P0595-015
January 25, 2023

Re: **Site Review Permit & Subdivision Applications
Proposed Advanced Manufacturing Facility**

PROPOSED ADVANCED MANUFACTURING FACILITY - TAC COMMENTS (12/30/2022) RESPONSE

80 Rochester Avenue (100 New Hampshire Avenue)
Portsmouth, New Hampshire
January 25, 2023

C-102

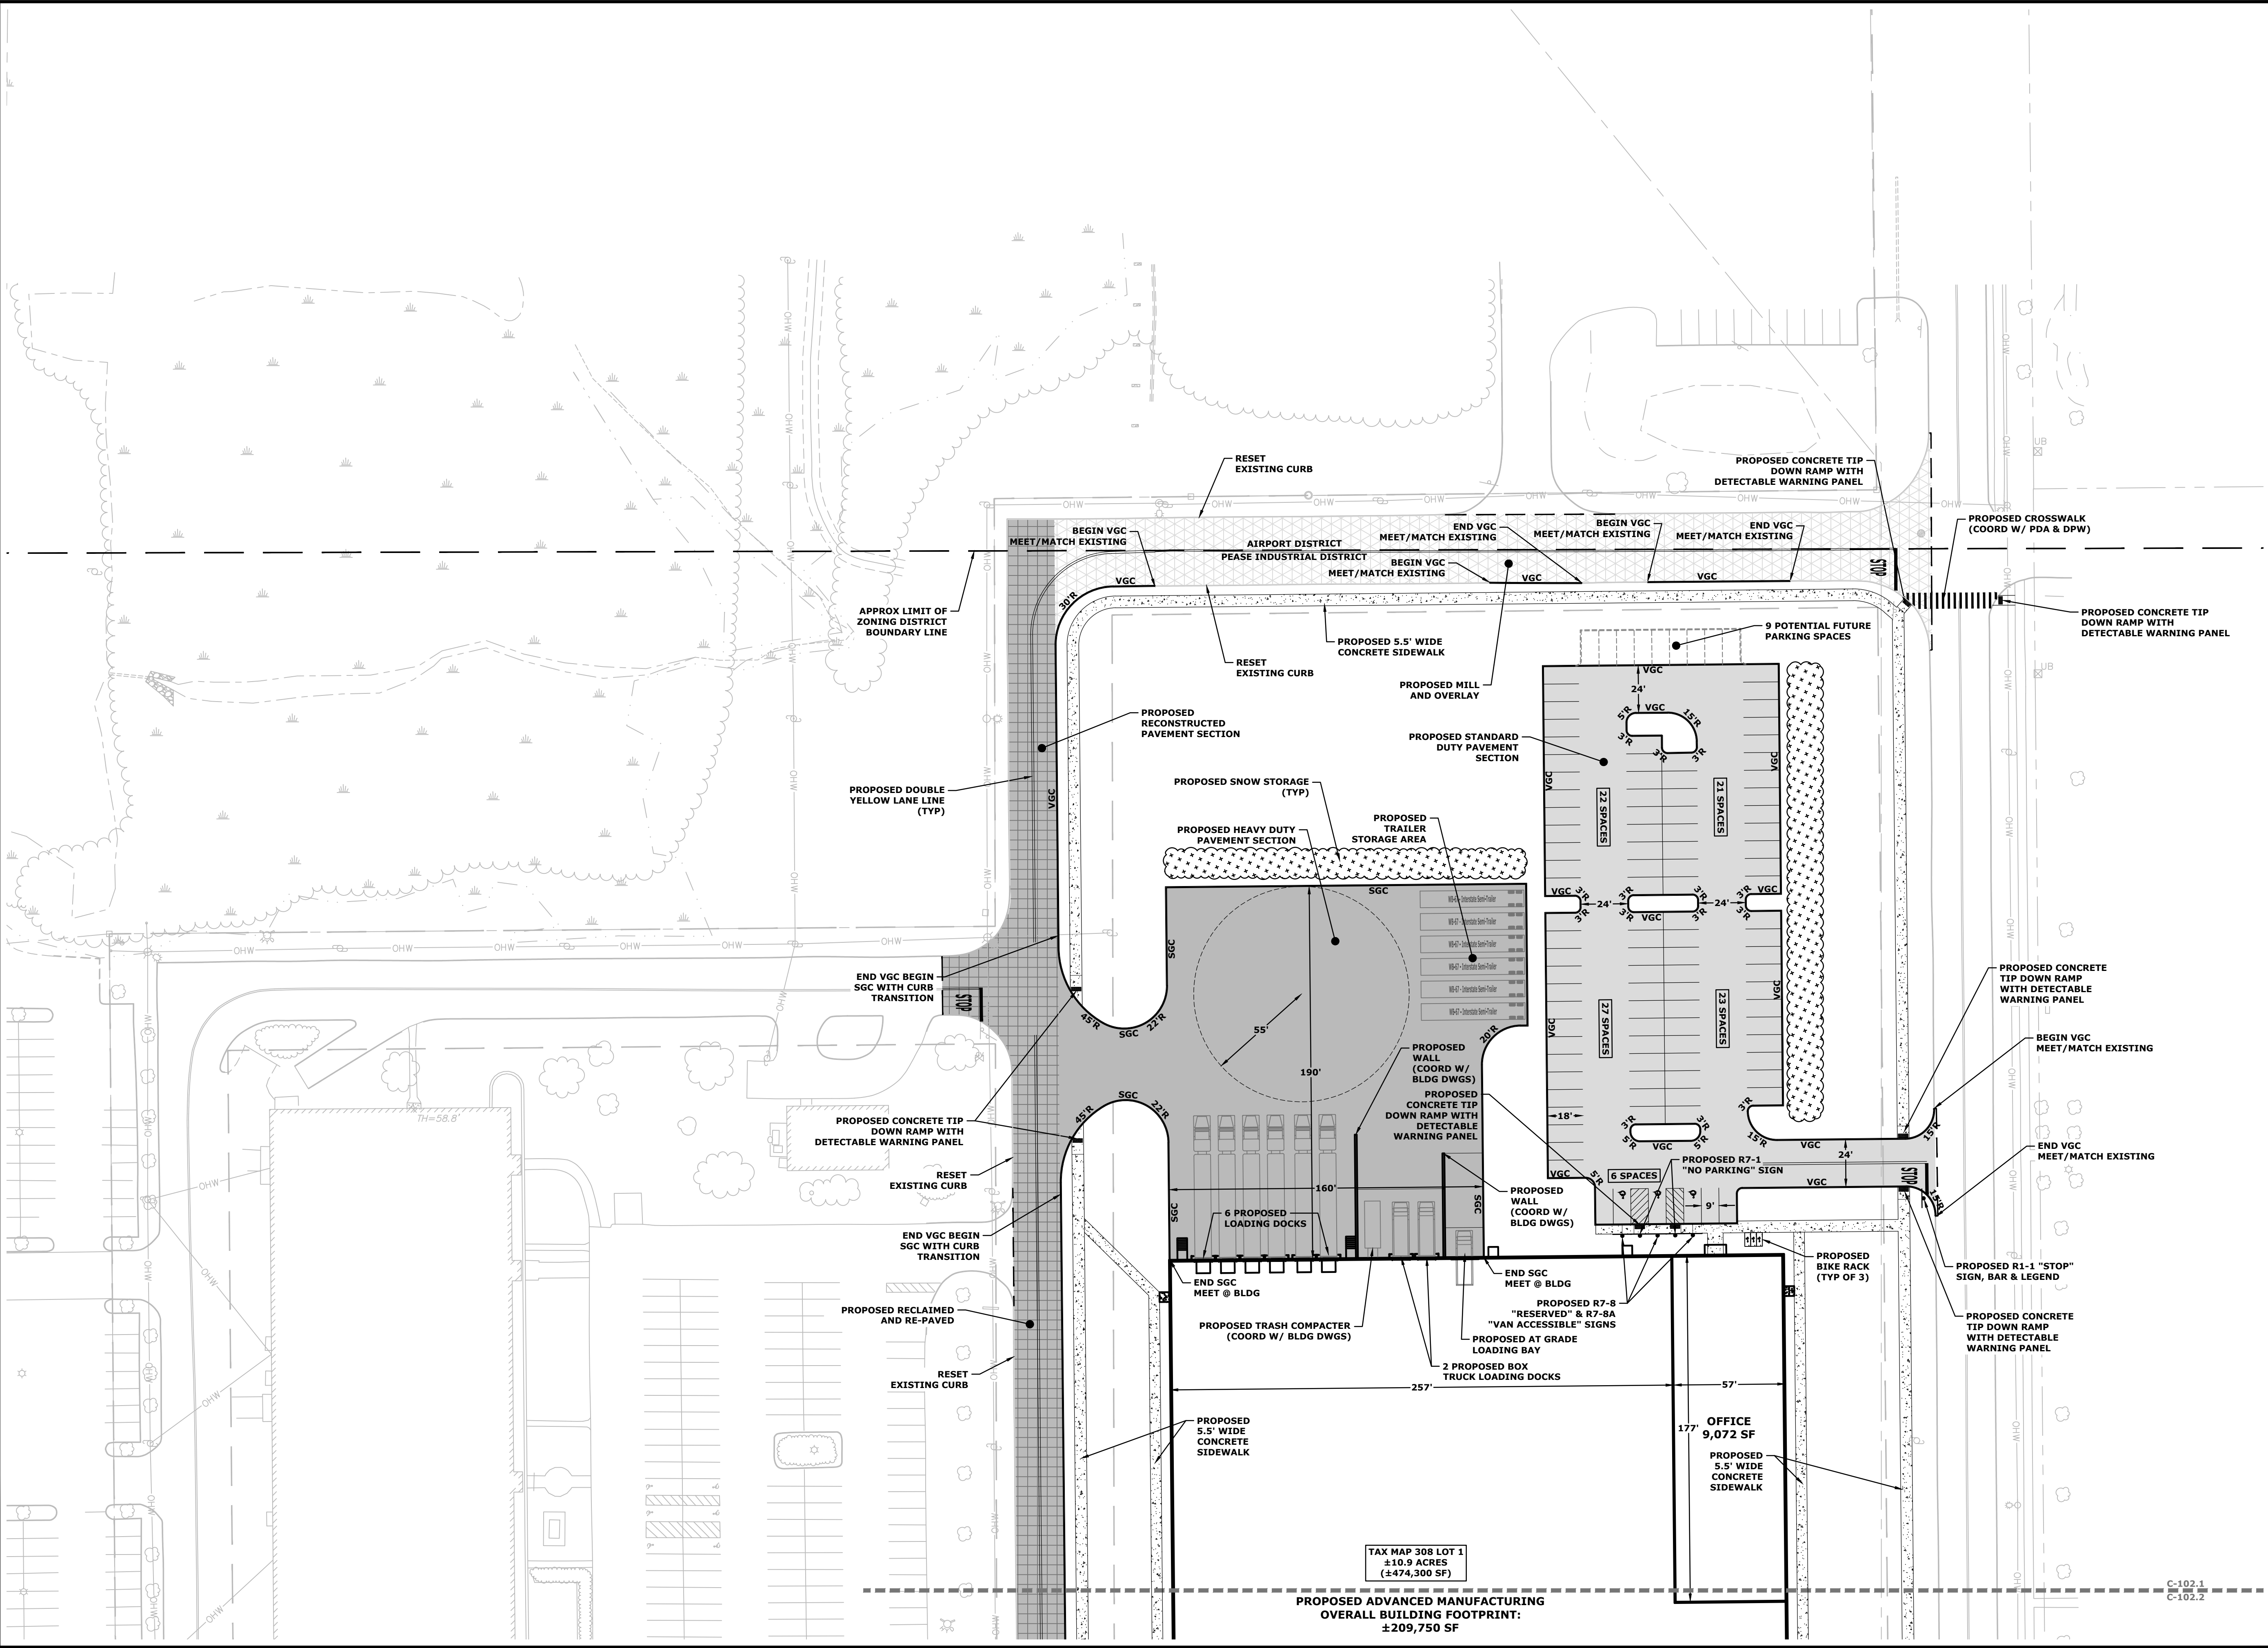
4	PCB 18 should tie into the street drainage, not the site drainage	The proposed grading in Rochester Avenue the entrances to each of the loading areas have been revised to make highpoints at the center of the drives and provide six (6) new catch basins within Rochester Avenue. In addition, the drainage analysis was updated to identify the overall reduction of impervious area within the Rochester Avenue Right of Way.	C-104 & Drainage Analysis
5	DMH 1925 is likely not large enough to accept such a large new core. Please confirm this design will work by investigating the structure with Stormwater division from DPW.	Based on Tighe & Bonds inspection of DMH 1925, which is a vault structure and not a typical circular manhole, the structure should be capable of accepting the increased opening for a new 48" HDPE vs. the existing 36" RCP pipe at this location.	C-103.2
6	Proposed sidewalk should be at least 5.5' wide, preferably 6' wide.	Sidewalk widths have been increased to 5.5'	C-102
